RANCHO SANTIAGO COMMUNITY COLLEGE DISTRICT

ADDENDUM NO. 1

Bid #1492 HVAC Replacement
at
Centennial Education Center

Project ID #2914.3

Scope of Work-BARD

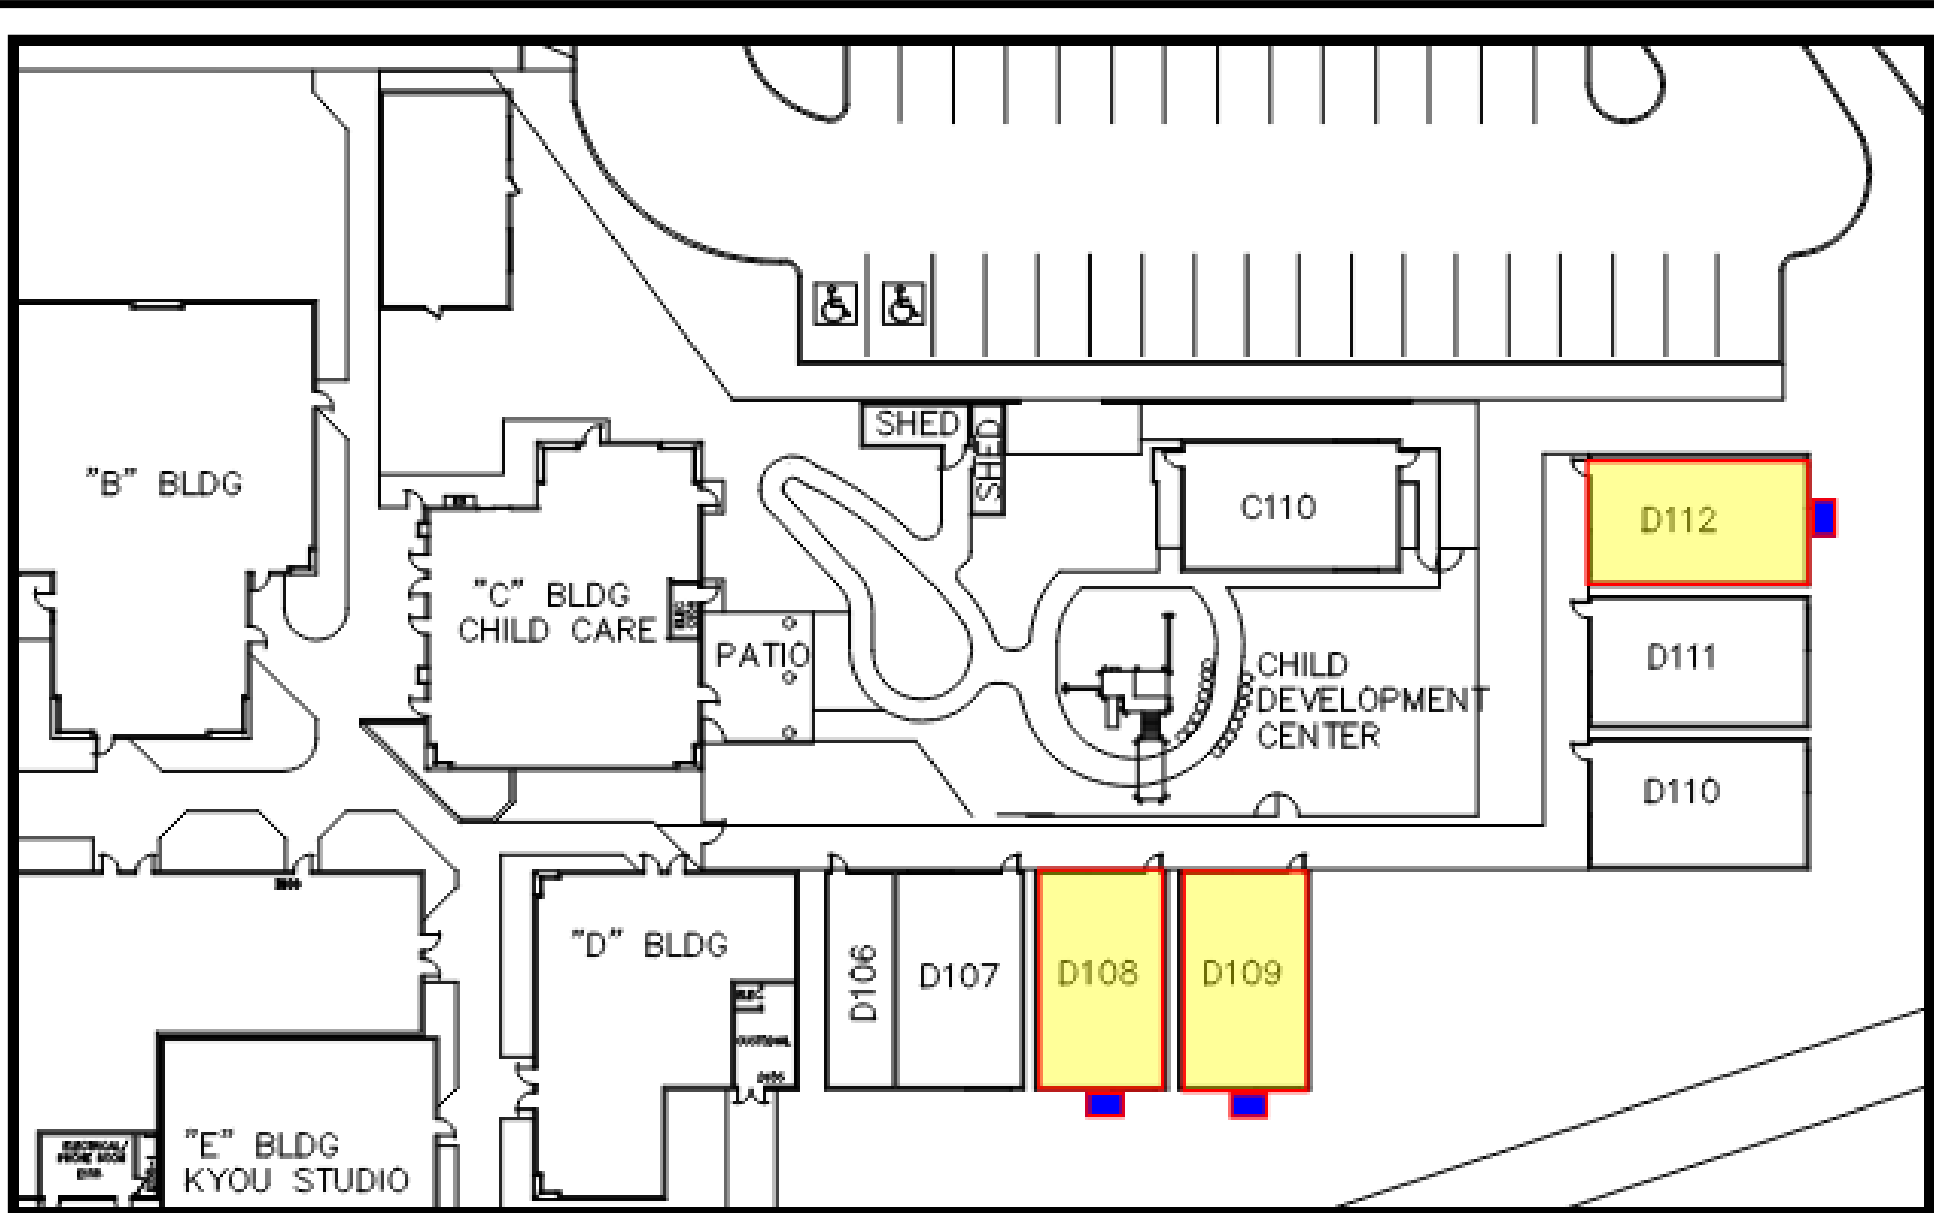
PROJECT NAME:	HVAC Replacement at Centennial Education Center		
PROJECT NUMBER:	2914.3	BID NUMBER:	1492
EMAIL TO: facilitiesbid@rscsd.edu			
DATE:	3/30/206		
FROM:	AC PROS INC	EMAIL:	estimating@acprosinc.com
SPEC SECTION:		DRAWING NUMBER:	Scope of Work -BARD, Note 2
REQUESTED CLARIFICATION:			
<p>Please advise if new disconnects will be installed or are we to re-use the existing?</p>			
RESPONSE TO CLARIFICATION:			
<p>Please see Scope of Work section as summarized below:</p> <p>2.1.4 Electrical Work•</p> <ul style="list-style-type: none"> ○ Contractor to remove existing local disconnect switch during demolition, and: ○ verify motor starting method is compatible with the existing electrical setup. ○ furnish and install new electrical fused disconnect within sight of the unit. ○ do not mount new electrical fused disconnect over the unit nameplate data.

PROJECT NAME:	HVAC Replacement at Centennial Education Center		
PROJECT NUMBER:	2914.3	BID NUMBER:	1492
EMAIL TO: facilitiesbid@rsccd.edu			
DATE:	3/30/206		
FROM:	AC PROS INC	EMAIL:	estimating@acprosinc.com
SPEC SECTION:		DRAWING NUMBER:	Scope of Work -BARD , Note 4
REQUESTED CLARIFICATION:			
<p>Per page 4 of the plans , " Scope of Work - BARD ".Please clarify the scope of work regarding the compressed air . How does the compressed air relate to the HVAC scope of work?</p>			
RESPONSE TO CLARIFICATION:			
<p style="text-align: center;">Please see revised Attachment A.Drawings Scope of Work.</p> <p style="text-align: center;">RSCCD - 04/01/2026</p>

- 1- "Safe-Off", electrically disconnect units. Lock-Out, Tag-Out at electrical panel Circuit Breaker.
- 2 - Remove existing electrical fused-service disconnect and replace with new.
- 3 - Remove the existing BARD HVAC Wall Mounted Unit from their location.
- ~~4 - Close and secure the compressed air line running to the building.~~
- 5-Contractor to provide proper disposal of used equipment.

- 2 - communicate observations/discrepancies with the RSCCD District Representative.
- 3 - **Contractor to remove existing local disconnect switch during demolition,** and:

- 4 - verify motor starting method is compatible with the existing electrical setup.
- 5 - **furnish and install new electrical fused disconnect within sight of the unit.**

- 6 - do not mount the new electrical fused disconnect over the unit nameplate data.
- 7 - provide and install equipment tag to the disconnect.
- 8 - all electrical re-connections to be of the highest workmanship, quality and in full compliance with the latest revision of the NEC Code.

Scope of Work-Marvair

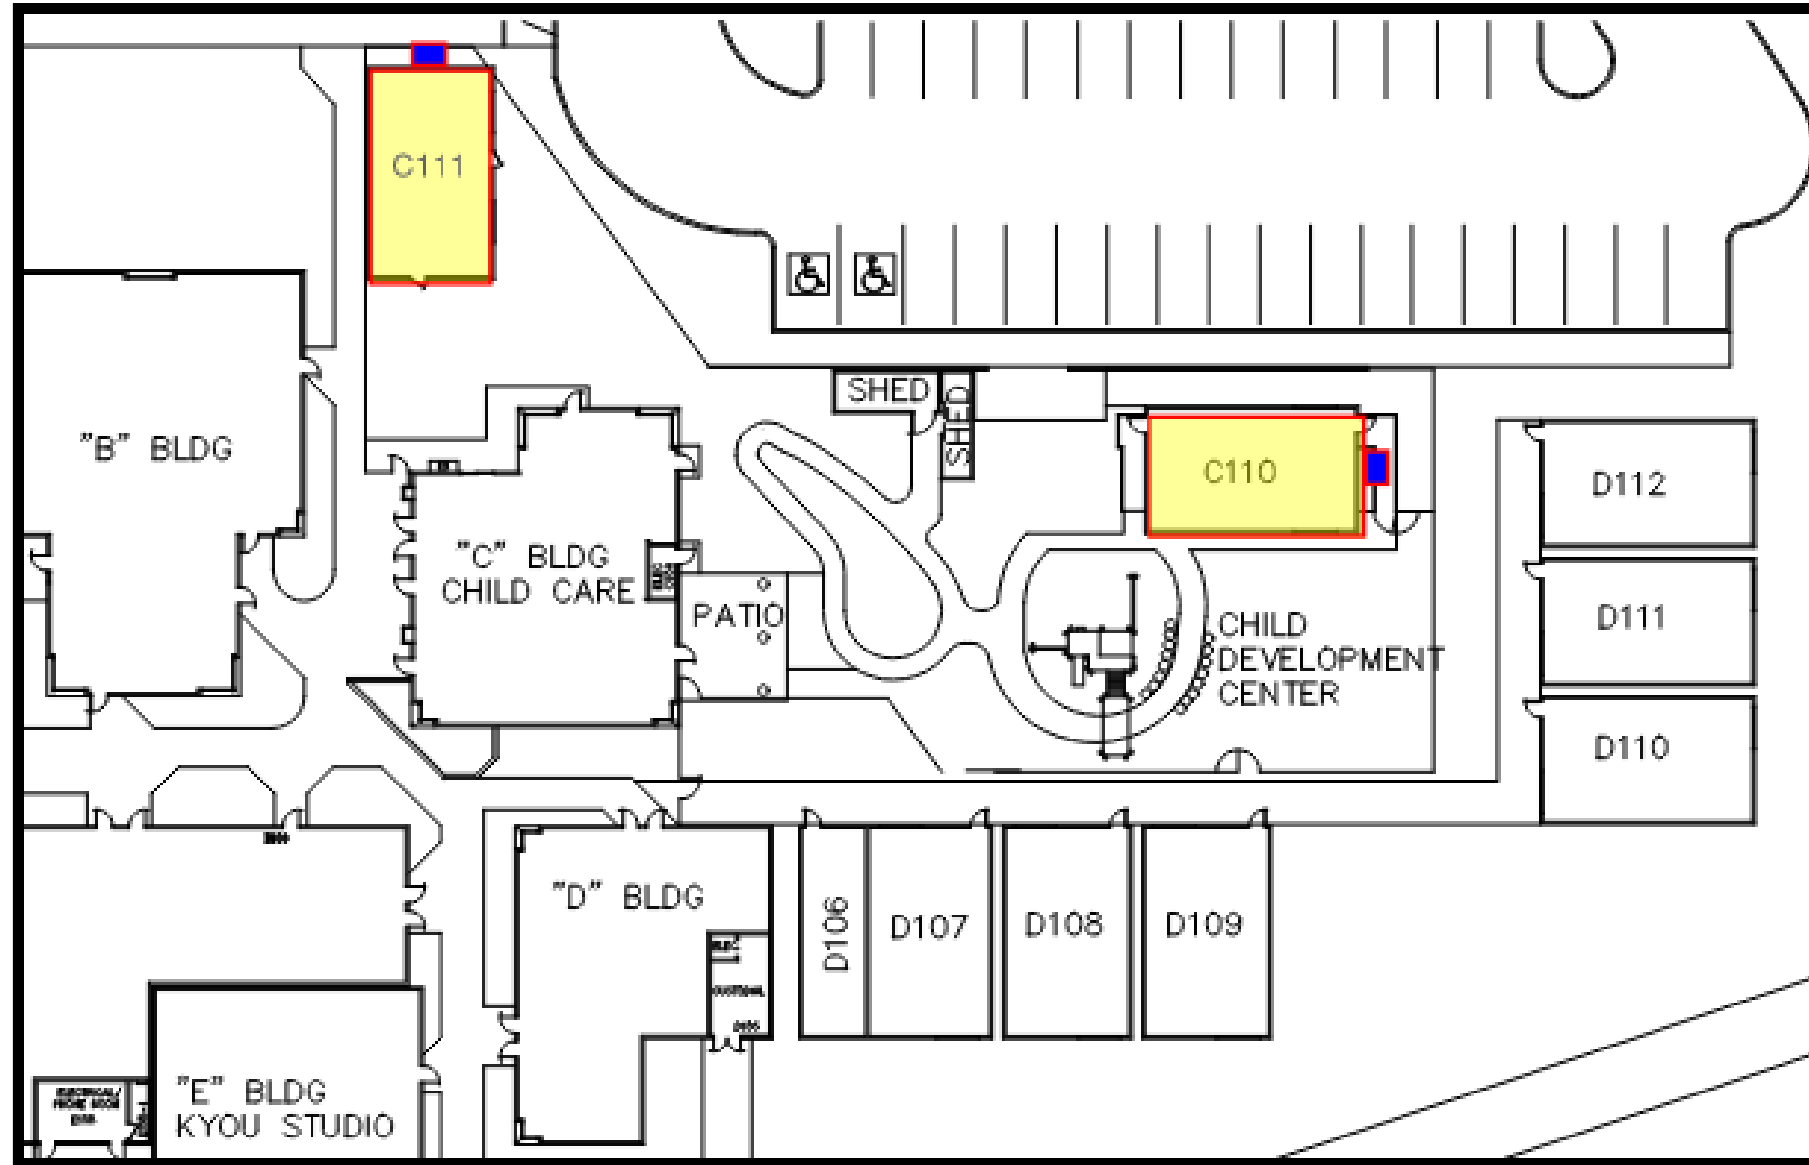
- 1 - "Safe-Off", electrically disconnect units. Lock-Out, Tag-Out at electrical panel Circuit Breaker.
- 2 - Remove existing electrical fused-service disconnect and replace with new.
- 3 - Remove the existing Marvair (Crispaire) Wall Mounted Unit from their location.
- 4 - ~~Close and secure the compressed air line running to the building.~~
- 5 - Contractor to provide proper disposal of used equipment
